## SERVICE INSTRUCTION no. 2012/3 – revision 1 Installing of basket wire stopper

With reference to: Singke wire baskets – K7, K10, K11, K13S

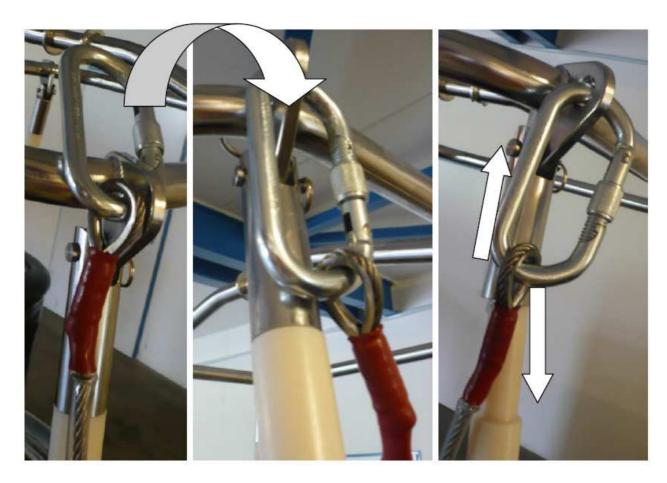
During windy inflation basket karabiner can be twisted so that the burner rod is detached from the burner socket. In that case the inflation must be interrupted and the burner frame returned to its original position. The effect is shown on the following pictures.

In order to prevent this issue we highly reccomend installation of "Basket wire stopper", order no. 54725.00. Just put on the karabiner the rubber eye as seen on the following picture.

The stopper holds the karabiner in its position so the karabiner cannot be twisted.
